ZONING CHANGE REVIEW SHEET

CASE: C814-2025-0111 (East Riverside PUD)

ADDRESS: 1404 East Riverside Drive

TO: PUD-NP

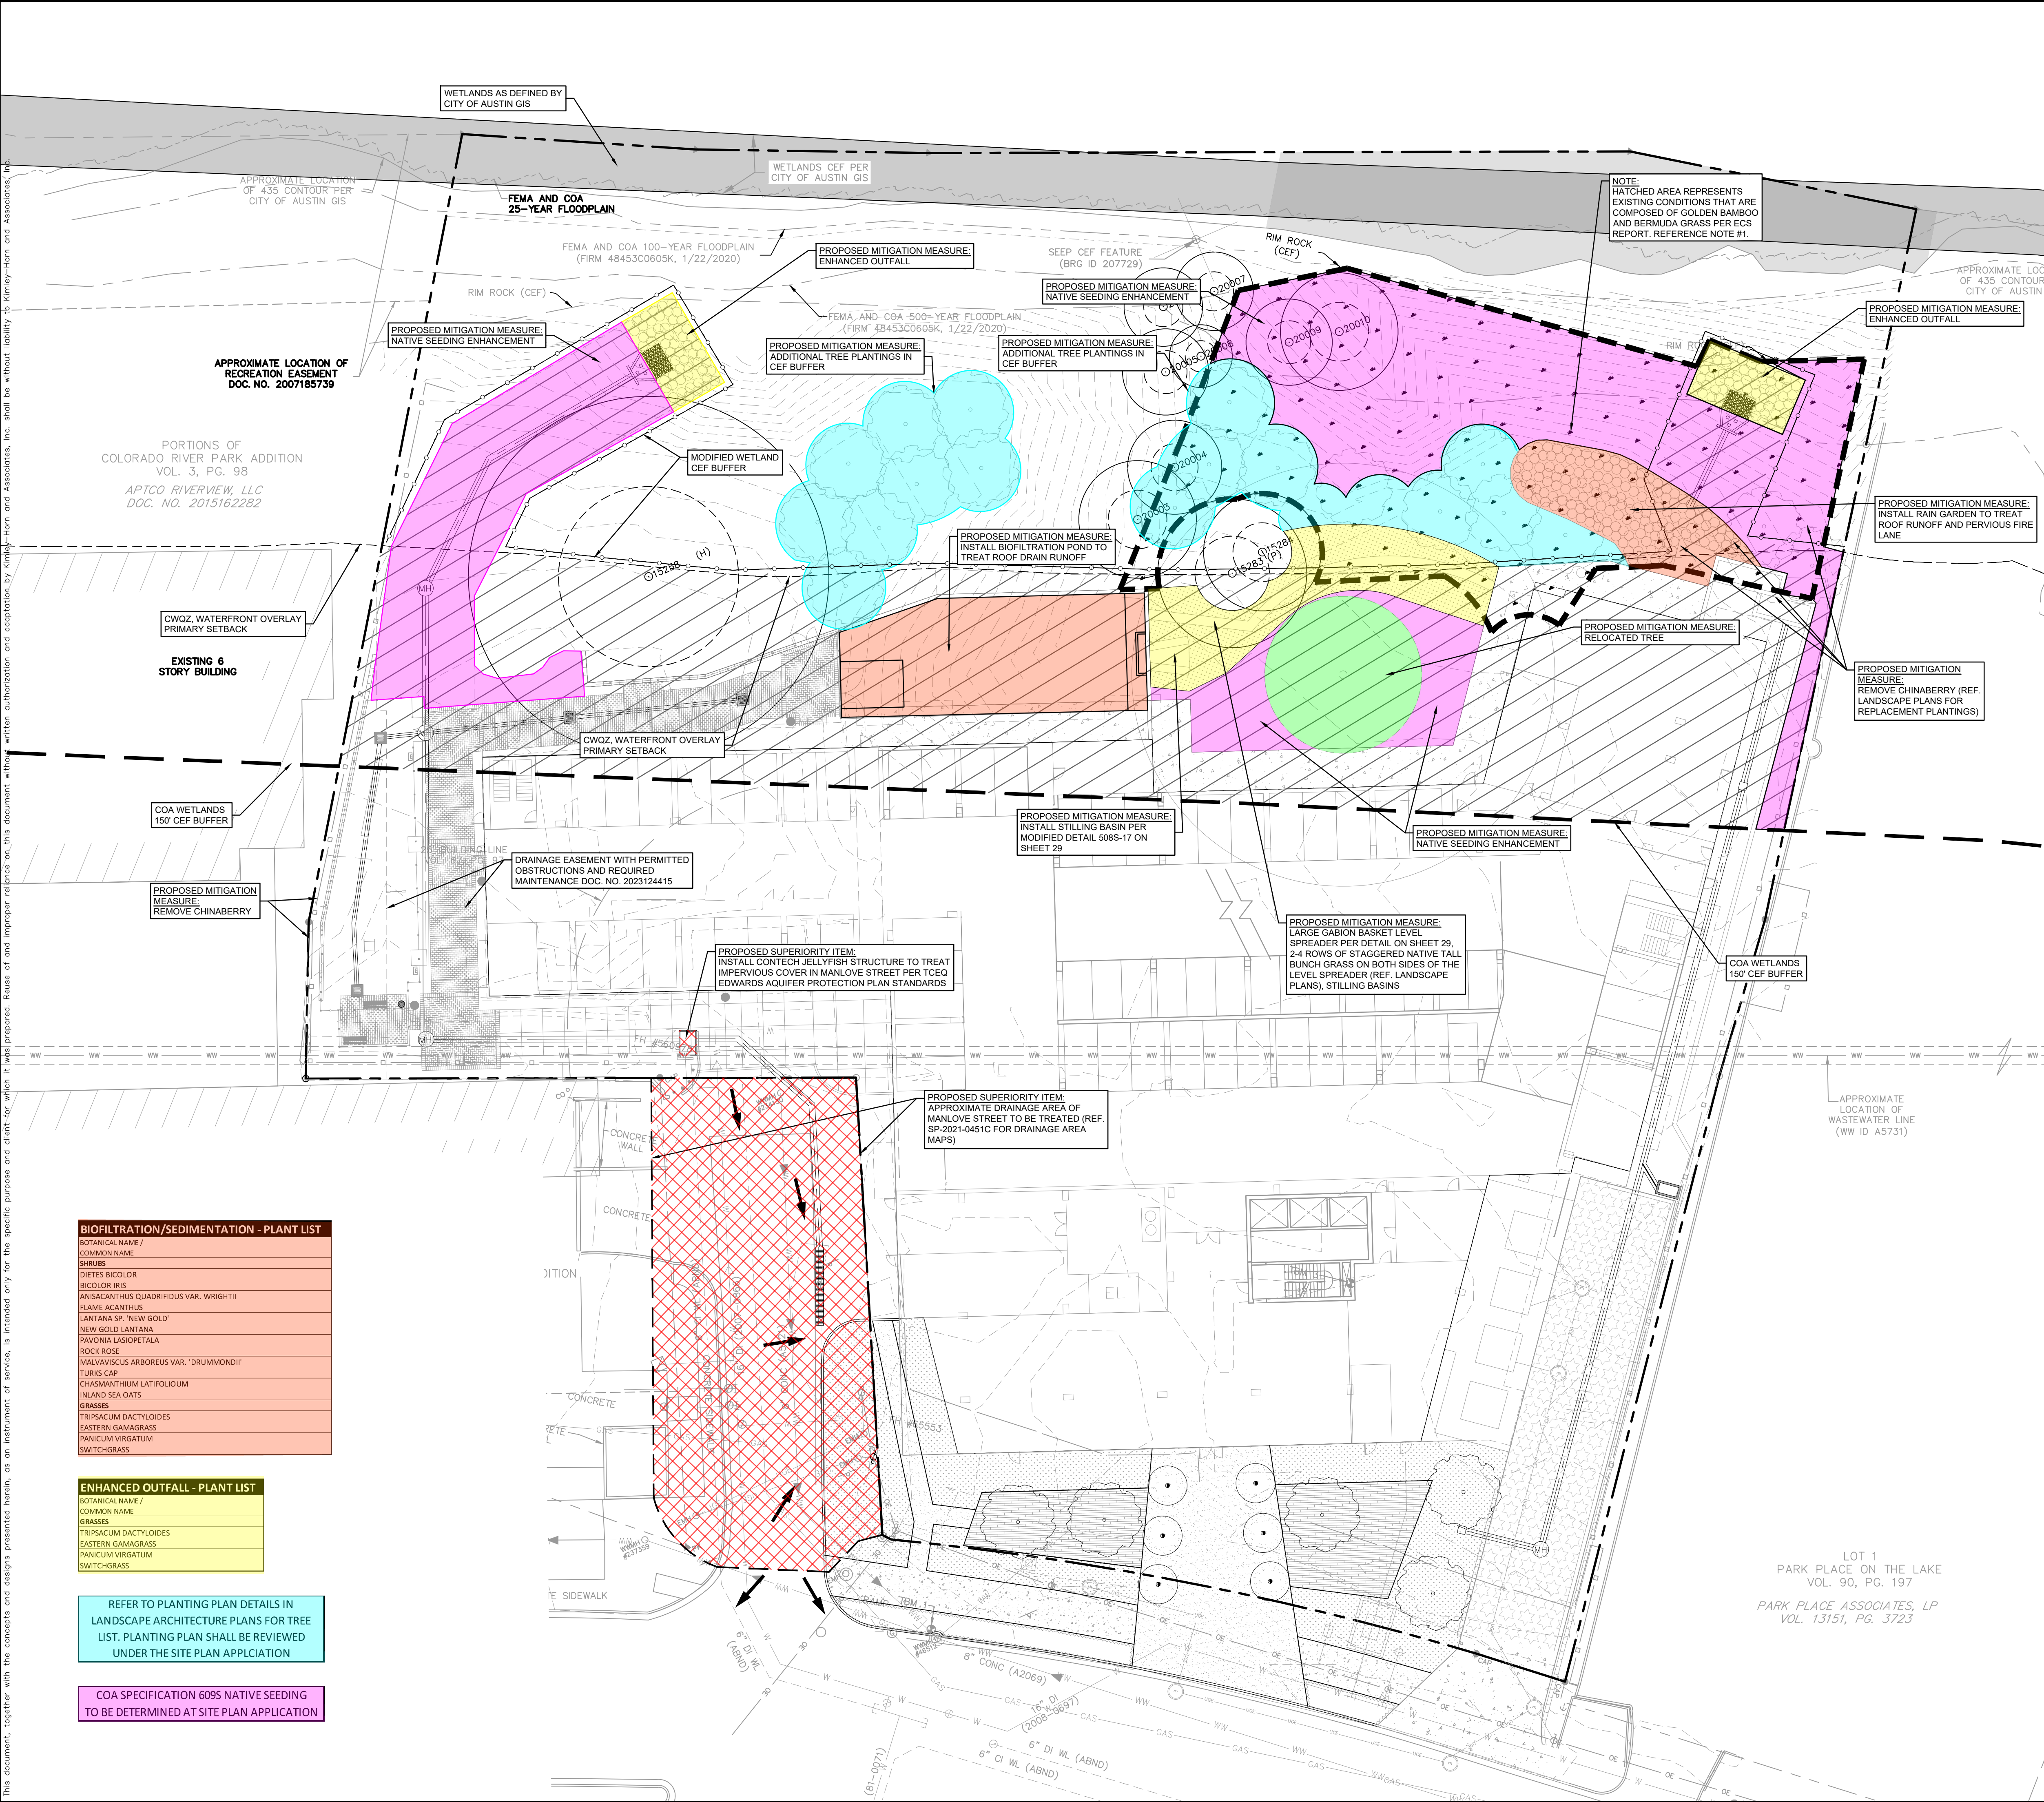
EO3. Provide an environmental exhibit showing areas of restoration, native plant lists, and other environmental enhancements (conceptual designs are acceptable and encouraged).

Update 1. The environmental exhibit shows both the required CEF mitigation and proposed superiority. However, it is unclear what enhancements are proposed as superior. Please clarify in this exhibit or provide a separate exhibit for the specific superior environmental enhancements.

U1. Comment partially addressed. Please replace *Buddleja marrubifolia* (likes very dry conditions) and *Galphimia glauca* (non-native) with *Rudbeckia hirta* or *Rudbeckia maxima* and *Chasmanthium latifolium* in your Biofiltration/Sedimentation Plant List.

WB5. Update 0. Please provide an exhibit which includes all environmental enhancements or environmental superiority efforts including restoration to the CWQZ, enhanced stabilization at the stormwater outfall(s) and any other environmental enhancements in addition to the wetland mitigation.

U1. Comment partially addressed. It is not clear to this reviewer what are the elements of environmental superiority. Please, distinguish between the minimum required mitigation and enhancements to be applied to the projects environmental superiority efforts.
